Anderson Dam Seismic Retrofit Project

Final Environmental Impact Report

Chapter 7

DRAFT EIR COMMENTS AND RESPONSES

Section 3.18, *Recreation*, Table 3.18-3 (Closures and Changes to Recreational Facilities in the Project Area), on Final EIR pages 3.18-39 and 3.18-40 has been revised as follows:

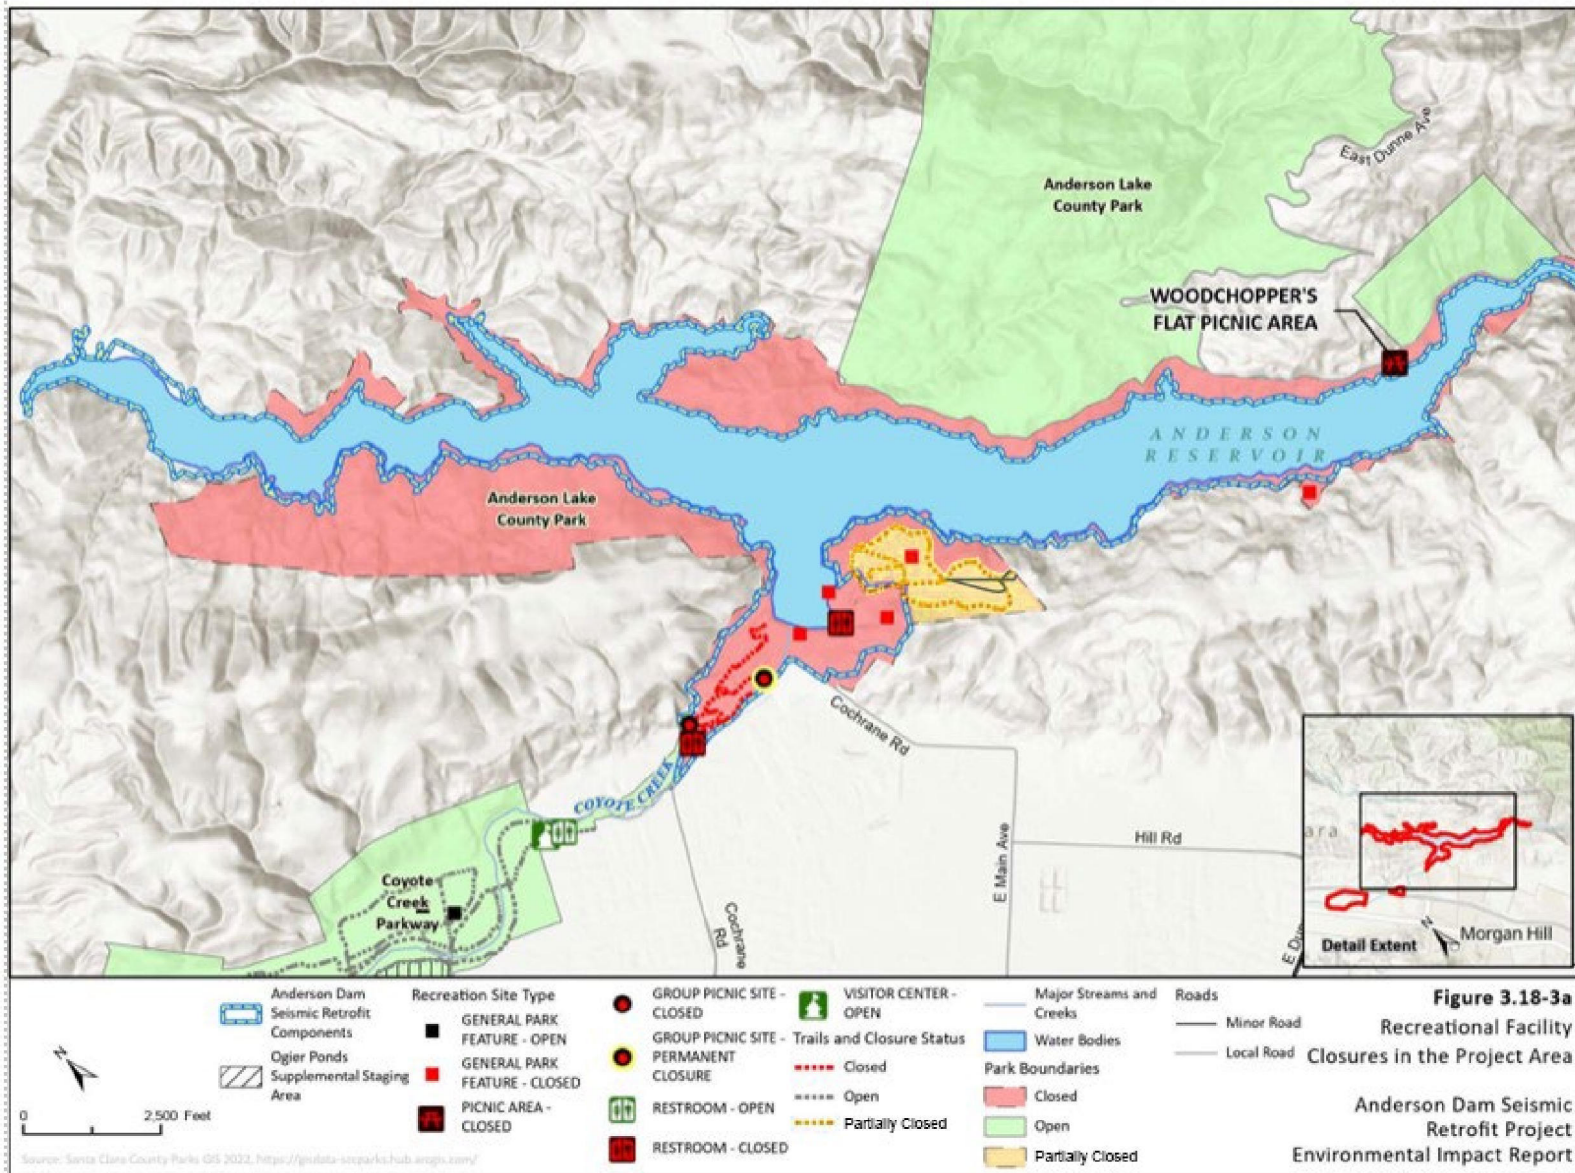
The originally proposed timeframe and location of the closure of the Rosendin Park Area were discussed in Draft EIR Chapter 2, *Project Description*, and Draft EIR Section 3.18, *Recreation*. The response below encompasses changes to the closure of trails within Lake Anderson County Park, including trails within and near the Rosendin Park Area, which are reflected the Final EIR.

Due to the proposed dam reconstruction activities within close proximity to the Rosendin Park Area, the Draft EIR impact analysis conservatively assumed the entire park would be closed through the entire construction period. However, in response to public comments, Valley Water has decided to limit the length, duration, and extent of the closure of the Rosendin Park Area in the following ways:

- The partial closures of Rancho Laguna Seca and Cochrane trails would remain as described in the Draft EIR and would extend throughout the entire construction period. Full closure of these trails is anticipated to occur for 3 to 4 months during the initial blasting activities associated with the Project with portions of them, as indicated on the revised figure below, reopened after the initial blasting period. The following changes to Table 3.18-3 and Figure 3.18-3b have been made to reflect the revised closures of the Rosendin Park Area.

Recreational Facility	Temporary Changes	Dates of Existing Conditions (FOCP) Closure	Dates of Project Related Construction Years Related to Temporary Closure	Duration of Project Related Temporary Closure (years)	Permanent Changes
Rosendin Park Area	Portions of trails that lead to/from Anderson Boat Ramp closed through FOCP, and all trails in Rosendin Park Area would be closed during <u>the initial blasting phase of construction of the seismic retrofit which would last for approximately 3-4 months. Trails closest to Basalt Hill Borrow Area would be closed for the duration of blasting.</u>	2020-2024	2024-2032 Years 4, 5, and/or 6	<u>12 Complete closures would last for approximately 3-4 months; partial closures of Rancho Laguna Seca and Cochrane trails would extend throughout the entire construction period. Lakeview Trail, Gray Pine Trail, Rosendin Trail and portions of Rancho Laguna Seca and Cochrane Trails would remain closed for the duration of blasting.</u>	No permanent changes are proposed at this recreational facility.
